**Well Name:** MORTON**Well Location:** T30N / R14W / SEC 23 /  
SENE / 36.802 / -108.27225**County or Parish/State:** SAN  
JUAN / NM**Well Number:** 1**Type of Well:** OTHER**Allottee or Tribe Name:****Lease Number:** NMNM26357**Unit or CA Name:****Unit or CA Number:****US Well Number:** 3004525506**Operator:** HILCORP ENERGY  
COMPANY

**Sundry ID:** 2821570**Type of Submission:** Subsequent Report**Type of Action:** Plug and Abandonment**Date Sundry Submitted:** 11/08/2024**Time Sundry Submitted:** 07:51**Date Operation Actually Began:** 11/04/2024**Actual Procedure:** Hilcorp Energy Company has plugged and abandoned the subject well on 11/7/2024 per the attached report.

**MORTON 1****30.045.25506****PLUG AND ABANDONMENT**

**Subject:** [EXTERNAL] P&A Revision Request for Hilcorp's MORTON 1 (API # 3004525506)

## Current Schematic - Version 3

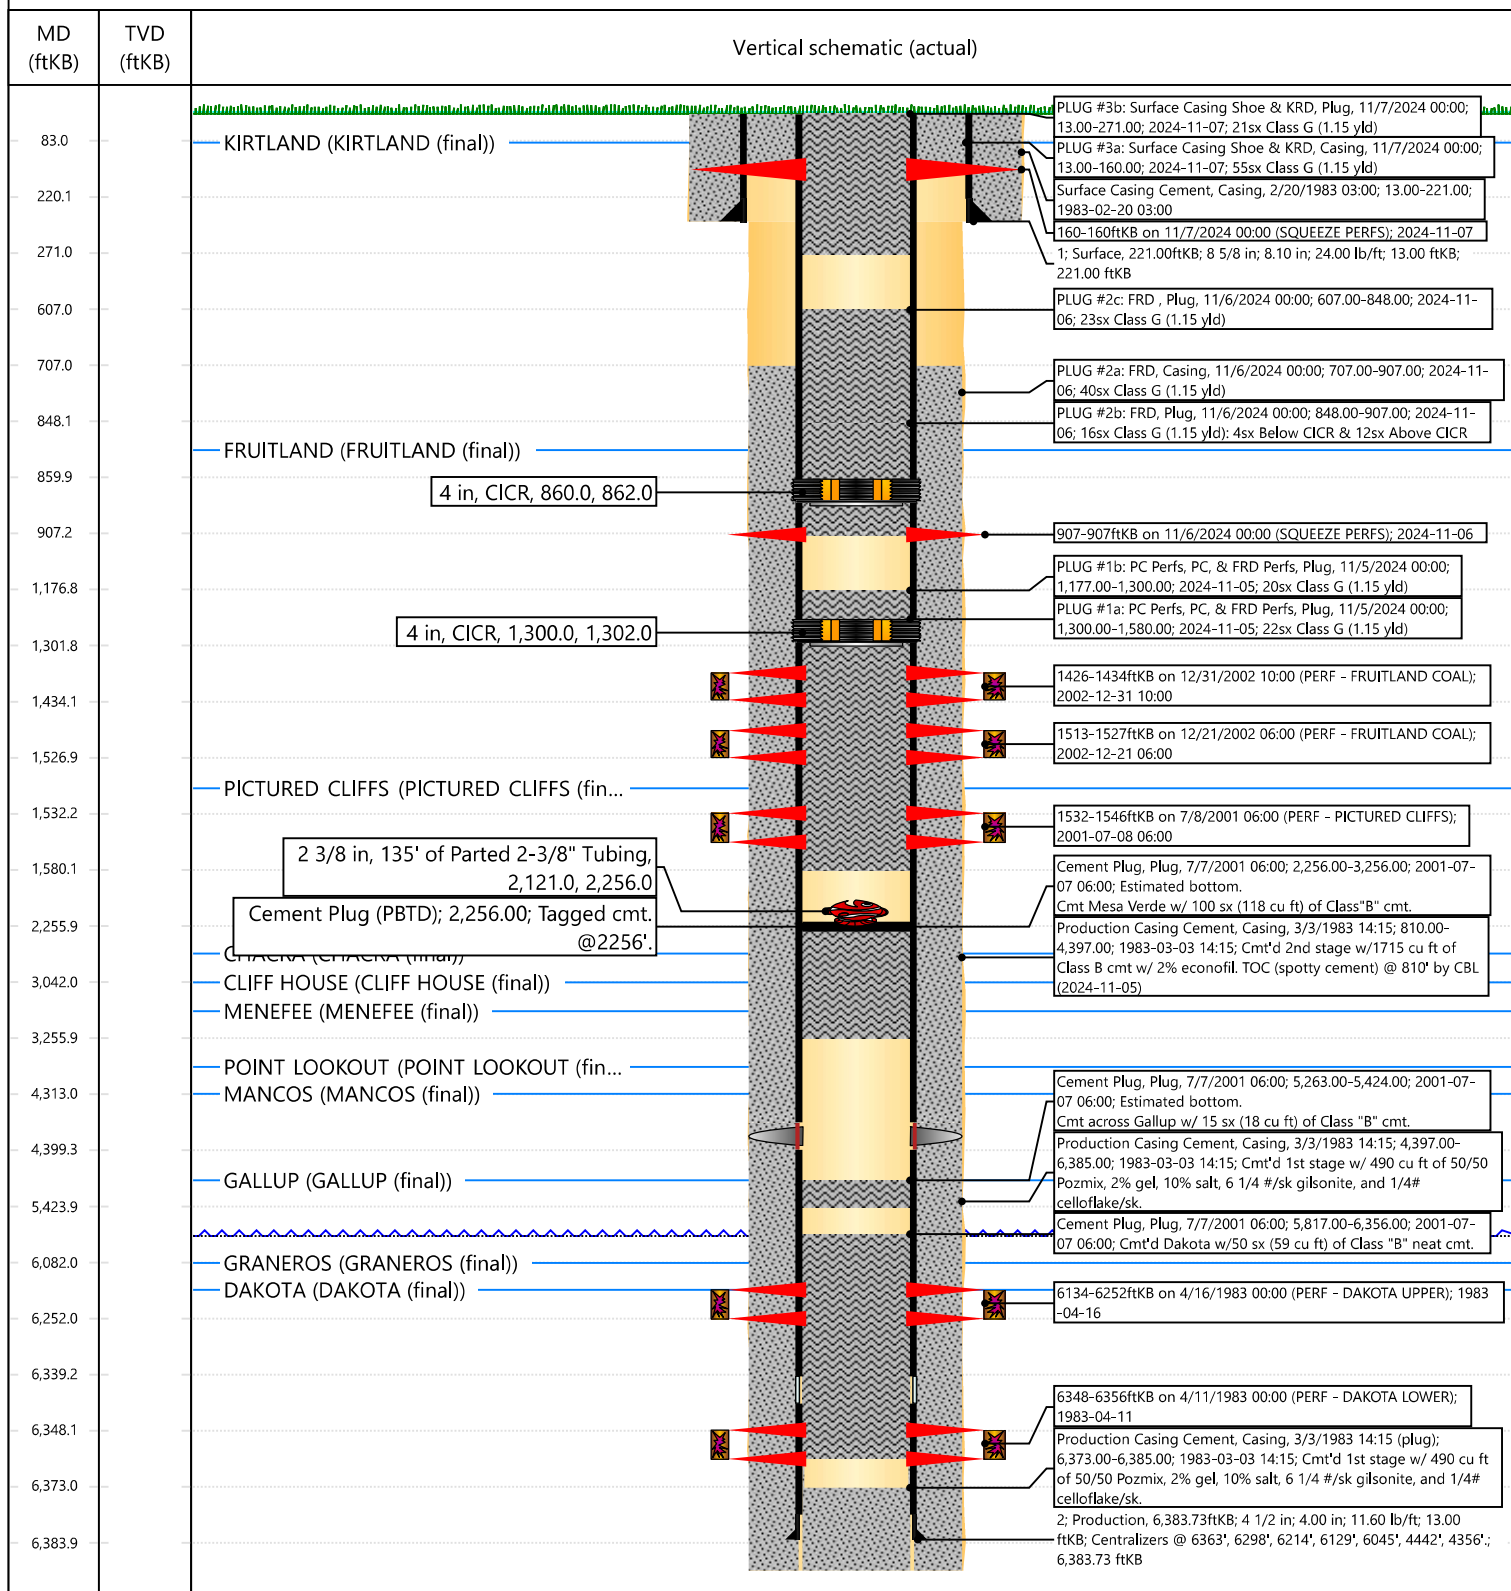
Per our discussion, after successfully pumping PLUG #2 as designed, HILCORP WOC & tagged TOC @ 848', 12' above the 4-1/2" CICR @ 860'.

Moving forward, Hilcorp received verbal approval from the NMOCD & BLM to pump a 150' balanced cement plug (12sx Class G 1.15 yld) on top of the existing TOC @ 848'. We will then WOC & tag.

Attached is the CBL that was run today (2024-11-05) on the MORTON 1. It shows spotty cement with a top @ ~810'.

Moving forward, Hilcorp received verbal approval from the NMOCD & BLM for the following adjustments to the procedure:

- **PLUG #1b: 12sx of Class G Cement (15.8 PPG, 1.15 yield); PC Perfs @ 1,532' | PC Top @ 1,530' | FRD Perfs @ 1,426'**
  - RIH w/ work string to top of CIRC @ 1,300'.

- Pump a 12 sack balanced cement plug on top of the CIRC. (est. **TOC @ +/- 1,150'** & est. **BOC @ +/- 1,300'**).
  - WOC for 4 hrs, tag TOC w/ work string. \*Note cement plug lengths and volumes account for excess.

- **PLUG #2: 52sx of Class G Cement (15.8 PPG, 1.15 yield); FRD Top @ 857':**
  - RU wireline; TIH & perf squeeze holes @ 907'.
  - RIH w/ **4-1/2" CIRC** & set @ **860'**. Sting into CIRC w/ work string. Establish injection.

- Pump 40sx of cement in the 4-1/2" casing X 7-7/8" open hole annulus (est. **TOC @ +/- 707'** & est. **BOC @ +/- 907'**). Pump an additional 4sx of cement beneath the 4-1/2" CIRC (est. **TOC @ +/- 860'** & est. **BOC @ +/- 907'**). Sting out of retainer, pump an 8 sack balanced cement plug on top of the CIRC. (est. **TOC @ +/- 757'** & est. **BOC @ +/- 860'**). WOC for 4 hrs, tag TOC w/ work string. \*Note cement plug lengths and volumes account for excess.

- **\*Note that if injection is unable to be established below CIRC set @ 860', Hilcorp received verbal approval from the NMOCD & BLM to forego pumping outside plug and proceed with pumping 150' plug only on top of the CIRC @ 860' (12sx Class G (1.15 yld) w/ est. TOC @ 710' & est. BOC @ 860').**

- **PLUG #3: 56sx of Class G Cement (15.8 PPG, 1.15 yield); Surf. Casing Shoe @ 221' | KR D Top @ 83':**
  - RU wireline; TIH & perf squeeze holes @ **160'** (Per NMOCD & BLM approval due to cement stringers below).

- TIH w/ work string to **271'**.

- Pump 35sx of cement in the 4-1/2" casing X 8-5/8" casing annulus (est. **TOC @ +/- 0'** & est. **BOC @ +/- 160'**). Pump a 21 sack balanced cement plug inside the 4-1/2" casing (est. **TOC @ +/- 0'** & est. **BOC @ +/- 271'**).
- WOC for 4 hrs, tag TOC w/ work string. \*Note cement plug lengths and volumes account for excess.
- Cut off wellhead, weld on P&A marker, & top off all strings.

Per our discussion, upon RIH w/ the 4-1/2" CICR, Hilcorp attempted to set the CICR @ 1,376' with no success.

Moving forward, Hilcorp received verbal approval from the NMOCD & BLM to set the 4-1/2" CICR @ 1,300'. Hilcorp will then increase the volume of PLUG #1a below the CICR to 22sx Class G (1.15 yld). Est TOC @ 1,300' & est. BOC @ 1,580'.

Per our conversation, upon rigging up on the MORTON 1 to begin P&A operations, we found that the tubing was parted, leaving ~135' of tubing in the wellbore.

Moving forward, Hilcorp received verbal approval from the NMOCD & BLM to leave the 135' fish in the wellbore and proceed with plugging operations as previously approved.

To confirm, the BLM finds the procedure appropriate.

NMOCD approves below with prior approval from the BLM

To confirm the BLM finds the procedure appropriate.

NMOCD approves moving CR to 1300 feet –

To confirm, the BLM finds the procedure appropriate.

NMOCD approves below

To confirm, the BLM finds leaving the tubing in hole appropriate.
